Access Compliance Report

Public Rights-of-Way

Intersection ID: 30489	Main Street: BEDDINGFIELD_DR	Cross Street: STONES_LANDING_ST	Location: SE
ADA ID: 22D16BEBBB10	Ramp Type: PerpDiag	Initial Pass/Fail: Fail	Overall Compliance: No
Severity Score: 8.75			
Codes/Mitigation Info/Possible Solution		Field Measurements/Component Compliance

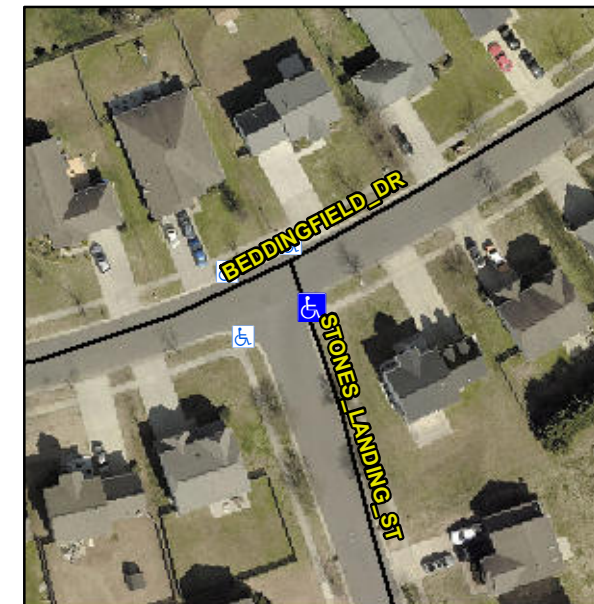
Not Found, R304.5.1

Compliance	Description	Data	Compliance	Description	Data
N/A	Ramp Length (in)	82.0	Yes	Ramp Slope (%)	5.0
No	Ramp Width (in)	47.0	Yes	Ramp XSlope (%)	0.8
N/A	Flare Type LT	N/A	N/A	Flare Type RT	N/A
N/A	Flare Slope LT (%)	N/A	N/A	Flare Slope RT (%)	N/A
N/A	Flare Traversable LT?	N/A	N/A	Flare Traversable RT?	N/A
N/A	Landing Length (in)	N/A	N/A	DWS Provided?	N/A
N/A	Landing Width (in)	N/A	N/A	DWS Contrast?	N/A
N/A	Landing Slope (%)	N/A	N/A	DWS Length (in)	N/A
N/A	Landing X Slope (%)	N/A	N/A	DWS Full Width?	N/A
N/A	Landing Curb? (Y/N)	N/A	N/A	DWS Offset (in)	N/A
N/A	Shared Landing?	N/A			
N/A	Gutter Ponding?	N/A	N/A	Gutter Slope (%)	N/A
N/A	Gutter Lip Ht (in)	N/A	N/A	Gutter X Slope (%)	N/A
N/A	Painted X Walk1?	No	N/A	Painted X Walk2?	No
	X Walk 1 Direction	To N		X Walk 2 Direction	To W
N/A	X Walk 1 Width (in)	N/A	N/A	X Walk 2 Width (in)	N/A
	X Walk 1 Slope (%)	4.5		X Walk 2 Slope (%)	1.9
	X Walk 1 X Slope (%)	2.5		X Walk 2 X Slope (%)	1.3

Remove & Replace Curb Ramp With Two New Directional Ramps or Equivalent.
